18 January 2023

**Re: Design Submission for Clonburris, Adamstown, Lucan, Dublin (the “Development”)
(the “Design Submission”) / Connection Reference No: CDS22008208**

**Our Ref: CDS22008208 Pre-Connection Enquiry
Clonburris, Adamstown, Lucan, Dublin**

Figure 4.1: SDZ Water Strategy Layout

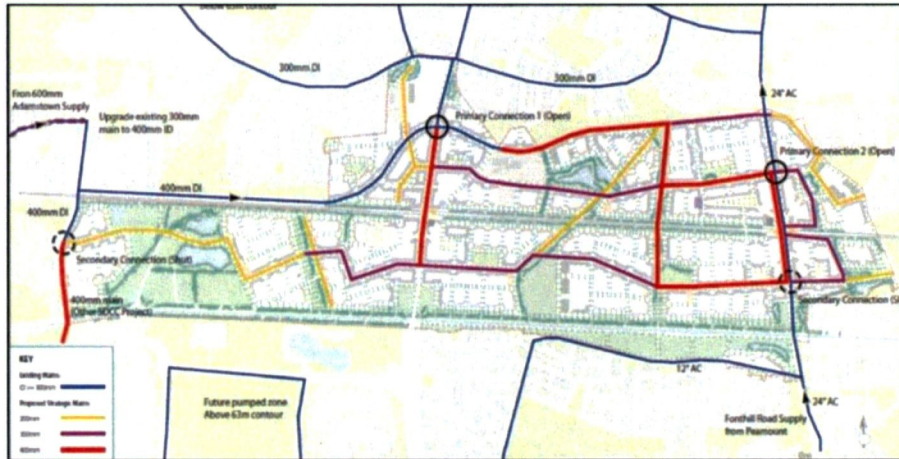
- **Water Connection** - Feasible without infrastructure upgrade by Irish Water
- The Development should be supplied, as a temporary solution, from the existing 400mm DI main (blue highlighted mains). Valves on the supply line must be adjusted to allow the water supply from Peamount Reservoir. A connection main should be a 150mm ID pipe with a control valve installed on the line. The control valve will be closed during normal operation, after a permanent connection installation.

- The Development is a part of Clonburris Development Zone and future (permanent) supply will be through the Zone from the East. Water infrastructure within the Development must be designed and installed in accordance with Clonburris SDZ Master Plan including the proposed 200mm main within the site boundaries. Developer is required to pay for the section of the future 200mm ID main.

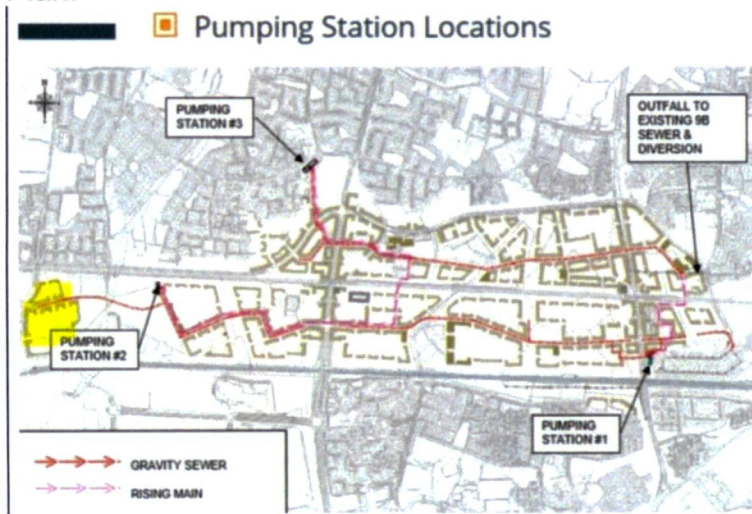
- The Development is a part of Clonburris Development Zone. In order to facilitate the proposed Development, all relevant core wastewater infrastructure within the Zone have to be completed, connected to the Irish Water network and in operation. That includes Clonburris Pumping Station 02, associated rising main and foul network (Northern Sewer Route) to be delivered by Clonburris Infrastructure Ltd (CIL).

- On an interim basis, a connection may be permitted in advance of completion of the Northern Sewer Infrastructure (to be delivered by CIL), subject to the delivery of Clonburris Pumping Station 01 (to be delivered by Irish Water), available capacity in PS01 at the moment, progress of works on the Northern Sewer Infrastructure and connection from customer site to PS01 (to be delivered by the Customer and CIL)

- All required works will need to be in accordance with Clonburris SDZ Master Plan.
